ANNEX "A"

Responses to Clarification Requests (Batch 4) General Bid Bulletin No. 12

**SOUTH COMMUTER RAILWAY PROJECT
FOR PACKAGES CP S-04, CP S-05, AND CP S-07
CONSTRUCTION OF CIVIL STRUCTURES: VIADUCTS, BRIDGES,
NINE (9) STATIONS AND DEPOT**

CP S04-07 Responses to Clarification Requests (Batch 4)

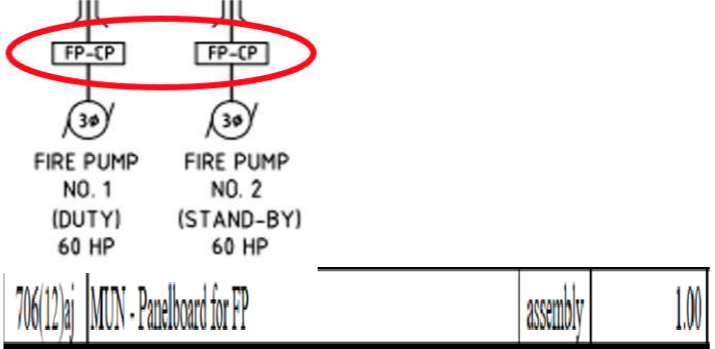
S-04	2	02.Book2. 04-S04 ELEC. CP S-04-04- ALA-EL	NSRP- DWG- ALA -EL- 5011 Bill No.4-1 BOQ 61 page	LOW VOLTAGE POWER SINGLE LINE DIAGRAM 1	Transfer switch	 <p>There is discrepancy between BOQ and design drawing. - in BOQ : 1200A - in Desing drawing : 800A Please clarify above item.</p>	<i>Please refer to GBB No. 11</i>
S-04	2	02.Book2. 04-S04 ELEC. CP S-04-04- ALA-EL	NSRP- DWG- ALA -EL- 5011 Bill No.4-1 BOQ 61 page	LOW VOLTAGE POWER SINGLE LINE DIAGRAM 1		 <p>There is discrepancy between BOQ and design drawing. - in BOQ : 1 ea - in Desing drawing : 2ea Please clarify above item.</p>	<i>Please refer to GBB No. 11</i>

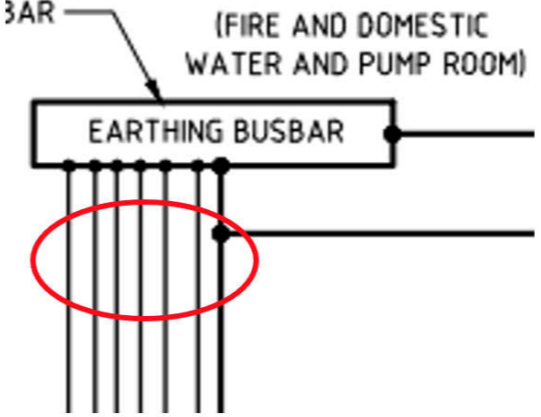
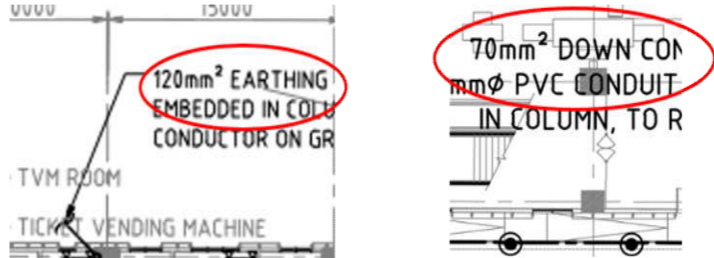
S-04	2	02.Book2. 04-S04 ELEC. CP S-04-03- ALA-EL	- NSRP- DWG- ALA -EL- 5101~510 3	EARTHING SCHEMATIC GROUND LEVEL AND CONCOURSE LEVEL		 <p>We can't find out some items in the BOQ because the specification of items are not in the relevant drawings. Please clarify that as following items; - Earthing cables</p>	<i>Please refer to GBB No. 11</i>

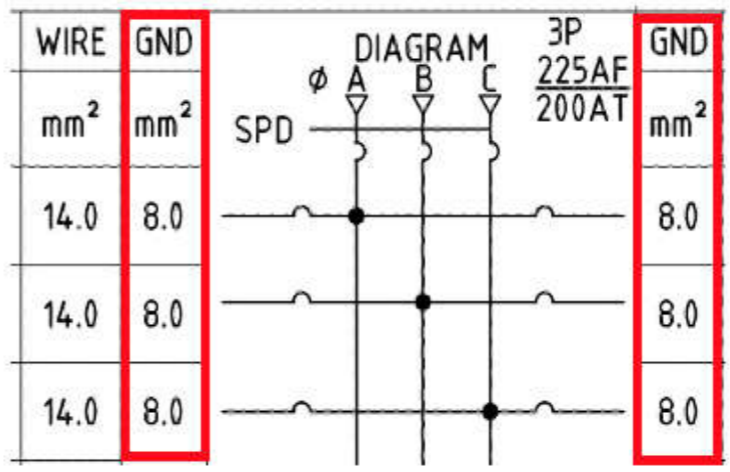
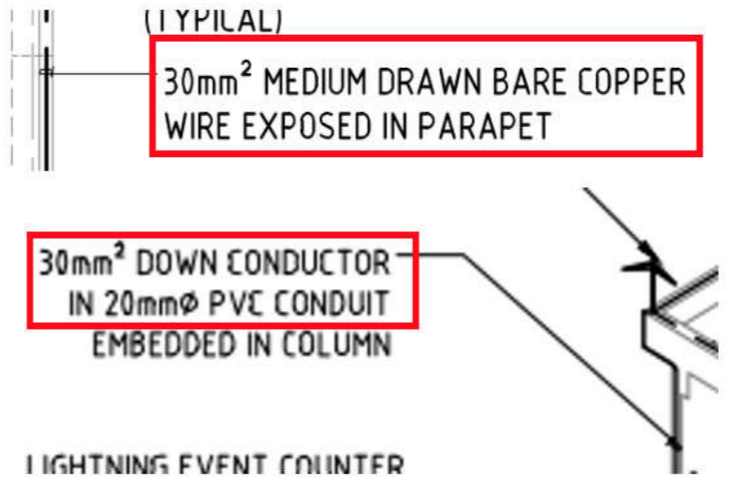
S-04	2	02.Book2. 04-S04 ELEC. CP S-04-03- MUN-EL	- NSRP- DWG- MUN - EL-5104	EARTHING INSTALLATION LAYOUT GROUND AND CONCOURSE LEVEL		 <p>We can't find out some items in the BOQ. But the items are in the relevant drawings. Please clarify that as following items;</p> <ul style="list-style-type: none"> - 120mm sq earthing conductor and 70mm sq down conductor 	<i>Please refer to GBB No. 11</i>

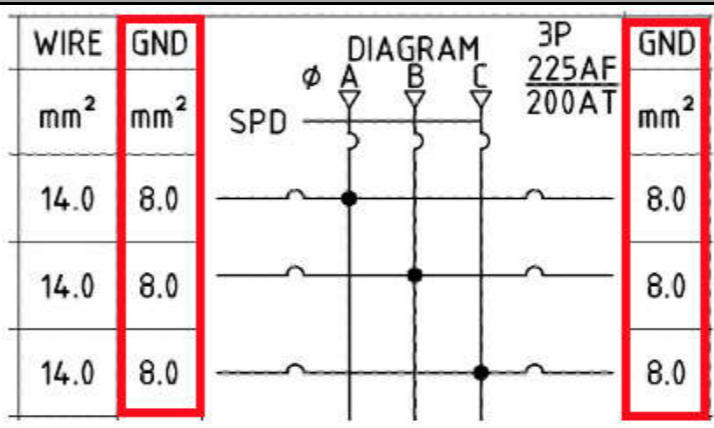
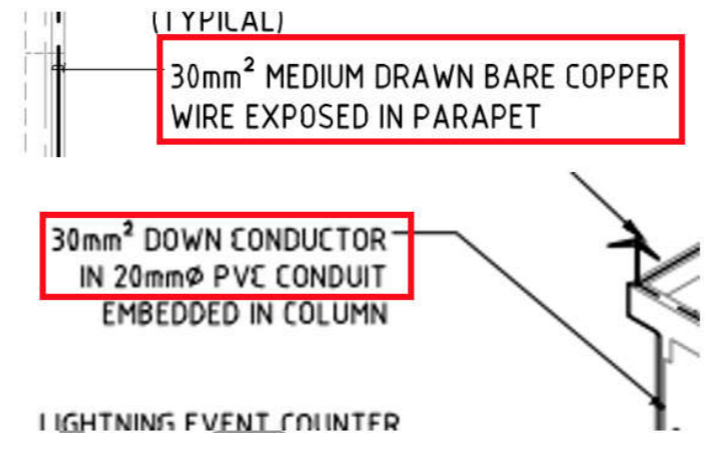
S-04	2	02.Book2. 04-S04 ELEC. CP S-04-03- MUN-EL	- NSRP- DWG- MUN - EL-5601	LIGHTNING PROTECTION LAYOUT ROOF LEVEL		<p>We can't find out some items in the BOQ. But the items are in the relevant drawings. Please clarify that as following items; - 70mm sq DOWN CONDUCTOR</p>	<i>Please refer to GBB No. 11</i>
S-04	2	02.Book2. 04-S04 ELEC. CPS-04-03- SS_Electrical_S S_07-09	NSRP- DWG- SS7-EL- 5500	ELECTRICLA PANELBOARD LOAD SCHEDULE	Panel ID LP1/LPE	<p>We can't find out some items in the BOQ. But the items are in the relevant drawings. Please clarify that as following items; - 40mm dia IMC Conduit for INCOMING WIRE</p>	<i>Please refer to GBB No. 11</i>
S-04	2	02.Book2. 04-S04 ELEC. CPS-04-03- SS_Electrical_S S_07-09	NSRP- DWG- SS7-EL- 5500	ELECTRICLA PANELBOARD LOAD SCHEDULE	Panel ID PP1	<p>We can't find out some items in the BOQ. But the items are in the relevant drawings. Please clarify that as following items; -Conductor and Conduit size (Incoming wire for PP1) : 4C x 100mm sq THHN + 1C x 60mm sq TW (G) 90mm dia IMC</p>	<i>Please refer to GBB No. 11</i>

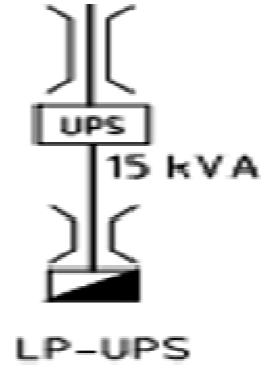
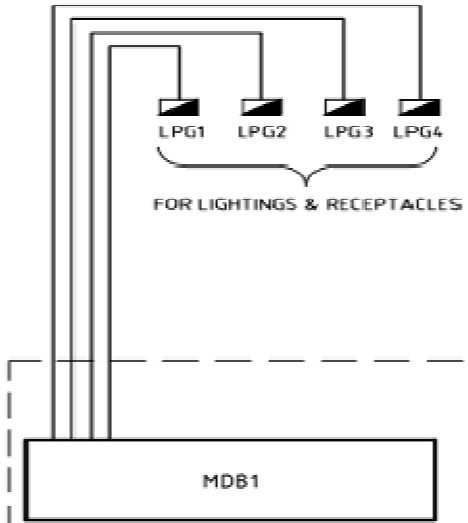
S-05	2	02.Book2. 04-S05 ELEC. CPS-05-03-SPO- EL.	NSRP- DWG- SPO -EL- 5011 Bill No.4- 1 BOQ 62 page	LOW VOLTAGE POWER SINGLE LINE DIAGRAM		 <p>There is discrepancy between BOQ and design drawing. - in BOQ : 1 ea - in Desing drawing : 2ea Please clarify above item.</p>	<i>Please refer to GBB No. 11</i>

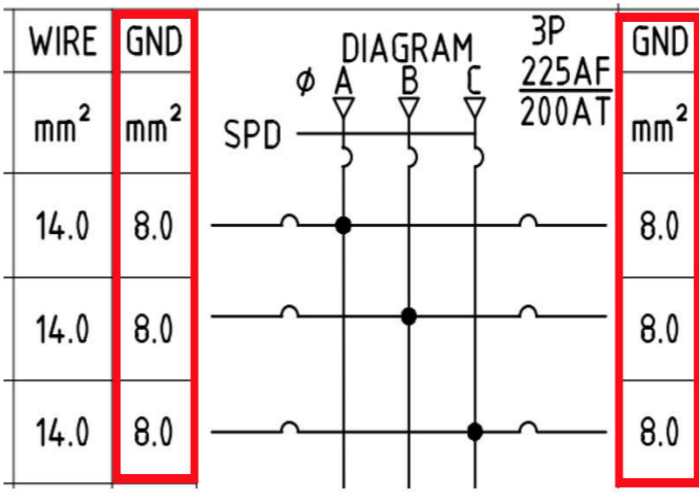
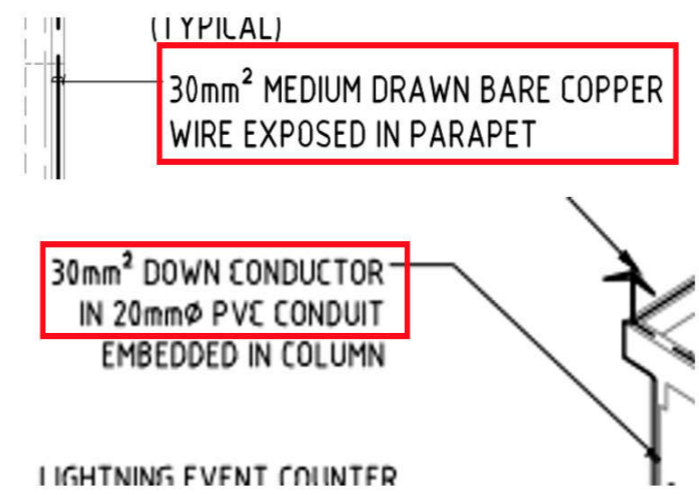
S-05	2	02.Book2. 04-S05 ELEC. CPS-05-03-SRO-EL	- NSRP-DWG-SRO -EL-5601	LIGHTNING PROTECTION LAYOUT ROOF LEVEL		<p>We can't find out some items in the BOQ. But the items are in the relevant drawings. Please clarify that as following items; - 70mmsq DOWN CONDUCTOR</p>	<i>Please refer to GBB No. 11</i>
S-05	2	02.Book2. 04-S05 ELEC. CPS-05-03-SS_Electrical_S_10-14	NSRP-DWG-SS10-EL-5500	ELECTRICLA PANELBOARD LOAD SCHEDULE	Panel ID LP1/LPE	<p>We can't find out some items in the BOQ. But the items are in the relevant drawings. Please clarify that as following items; - 40mm dia IMC Conduit for INCOMING WIRE</p>	<i>Please refer to GBB No. 11</i>
S-05	2	02.Book2. 04-S05 ELEC. CPS-05-03-SS_Electrical_S_10-14	NSRP-DWG-SS10-EL-5500	ELECTRICLA PANELBOARD LOAD SCHEDULE	Panel ID PP1	<p>We can't find out some items in the BOQ. But the items are in the relevant drawings. Please clarify that as following items; - Conductor and Conduit size (Incoming wire for PP1) : 4C x 150mm sq THHN + 1C x 80mm sq TW (G) 100mm dia IMC</p>	<i>Please refer to GBB No. 11</i>

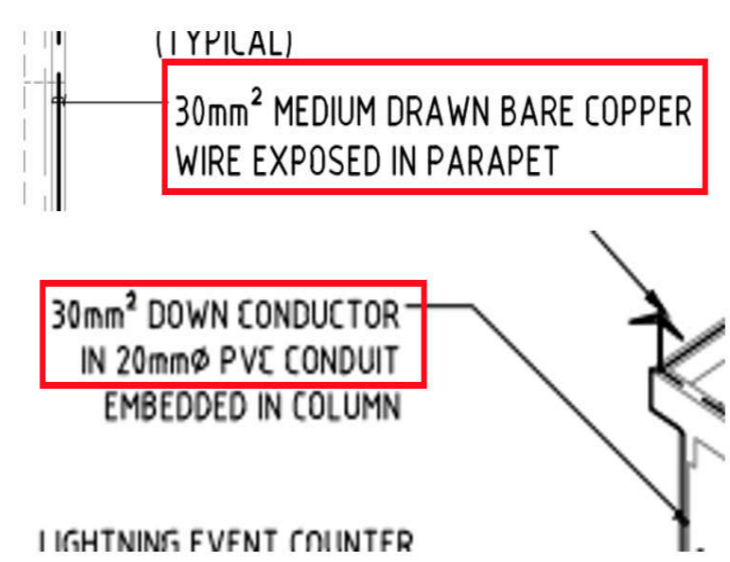
<p>We can't find out some items in the BOQ. But the items are in the relevant drawings. Please clarify that as following items; - Grounding cable (8mm sq)</p>	WIRE	GND	mm ²	mm ²	14.0	8.0	14.0	8.0	14.0	8.0	<i>Please refer to GBB No. 11</i>
WIRE	GND																
mm ²	mm ²																
14.0	8.0																
14.0	8.0																
14.0	8.0																
S-05	2	02.Book2. 04-S05 ELEC. CPS-05-03- SS_Electrical_S S_10-14	NSRP- DWG- SS11-EL- 5601	ELECTRICAL LIGHTNING INSTALLATION LAYOUT ROOF LEVEL		 <p>The diagram shows a lightning event counter installation. Callouts indicate:</p> <ul style="list-style-type: none"> 30mm² MEDIUM DRAWN BARE COPPER WIRE EXPOSED IN PARAPET 30mm² DOWN CONDUCTOR IN 20mmØ PVC CONDUIT EMBEDDED IN COLUMN <p>LIGHTNING EVENT COUNTER</p> <p>We can't find out some items in the BOQ. But the items are in the relevant drawings. Please clarify that as following items; - 30mm sq medium drawn bare copper wire and 30mm sq down conductor - 20mm dia PVC Conduit</p>	<i>Please refer to GBB No. 11</i>										
S-05	2	02.Book2. 04-S05 ELEC. CPS-05-03- SS_Electrical_S S_10-14	NSRP- DWG- SS12-EL- 5500	ELECTRICLA PANELBOARD LOAD SCHEDULE	Panel ID LP1/LPE	We can't find out some items in the BOQ. But the items are in the relevant drawings. Please clarify that as following items; - INCOMING WIRE(4C x 14mm sq THHN + 1C x 5.5mm sq TW(G) - 40mm dia IMC Conduit for INCOMING WIRE	<i>Please refer to GBB No. 11</i>

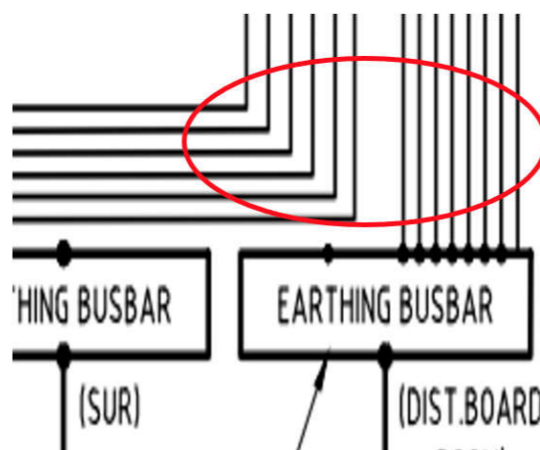
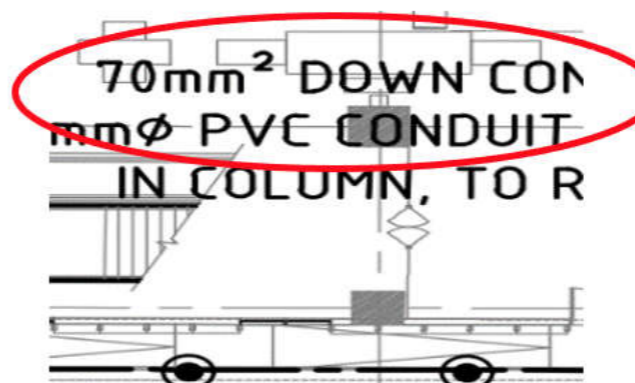
S-06	2	02.Book2. 04-S06 ELEC. CP S-06-03- CAB-EL.	NSRP- DWG- CAB-EL- 5011	LOW VOLTAGE POWER SINGLE LINE DIAGRAM 1		 <p>We can't find out some items in the BOQ. But the items are in the relevant drawings. Please clarify that as following items;</p> <ul style="list-style-type: none"> - Generator 	<i>Please refer to GBB No. 11</i>

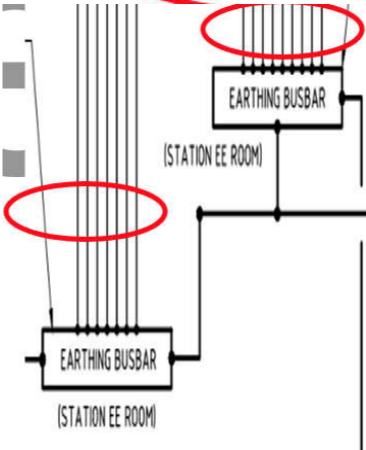
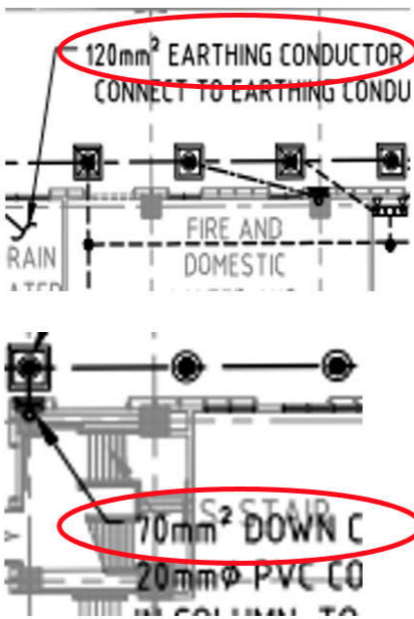
S-06	2	02.Book2. 04-S06 ELEC. CP S-06-03- CAB-EL.	- NSRP- DWG- CAB -EL- 5104	EARTINGING INSTALLATION LAYOUT GROUND AND CONCOURSE LEVEL		 <p>The diagram shows a cross-section of a toilet column with an earthing conductor. The text 'EARTHING CONDUCTOR' is circled in red.</p> <p>Please clarify that as following item because the size of item is not marked ; - Earthing conductor</p>	<i>Please refer to GBB No. 11</i>

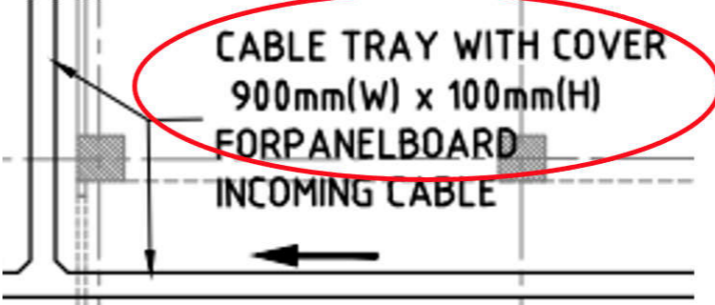
S-06	2	02.Book2. 04-S06 ELEC. CP S-06-03- CAB-EL.	- NSRP- DWG- CAB -EL- 5500	PANELBOARD LOAD SCHEDULE SHEET 1	Panel ID FP-DB	<p>We can't find out some items in the BOQ. But the items are in the relevant drawings. Please clarify that as following items; - Conductor size (From FP-DB to DBSF) : 4C x 80mm sq + 1C x 38mm sq (G) Fire Rated LSZH Cable - Conductor size (From FP-DB to DB-GEN) : 4C x 150mm sq + 1C x 80mm sq (G) Fire Rated LSZH Cable</p>	<i>Please refer to GBB No. 11</i>
S-06	2	02.Book2. 04-S06 ELEC. CP S-06-03- CAB-EL.	- NSRP- DWG- CAB -EL- 5601	LIGHTNING PROTECTION LAYOUT ROOF LEVEL		<p>We can't find out some items in the BOQ. But the items are in the relevant drawings. Please clarify that as following items; - 70mm sq DOWN CONDUCTOR</p>	<i>Please refer to GBB No. 11</i>

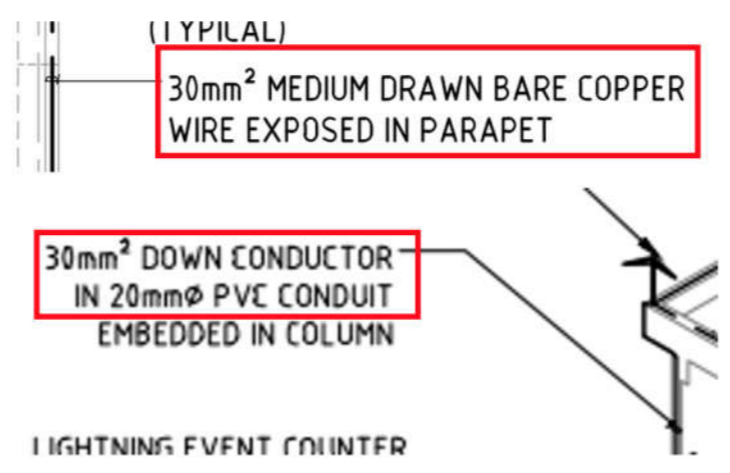
<p>We can't find out some items in the BOQ. But the items are in the relevant drawings. Please clarify that as following items; - Grounding cable (8mm sq)</p>	DESCRIPTION	CKT. BKR.			WIRE	GND	POL E	AF	AT	mm ²	mm ²	CDU-01(MEETING ROOM)	1	100	70	14.0	8.0	CDU-02 (SUBSTATION)	1	100	60	14.0	8.0	CDU-02 (SUBSTATION)	1	100	60	14.0	8.0	<i>Please refer to GBB No. 11</i>
DESCRIPTION	CKT. BKR.			WIRE	GND																															
	POL E	AF	AT	mm ²	mm ²																															
CDU-01(MEETING ROOM)	1	100	70	14.0	8.0																															
CDU-02 (SUBSTATION)	1	100	60	14.0	8.0																															
CDU-02 (SUBSTATION)	1	100	60	14.0	8.0
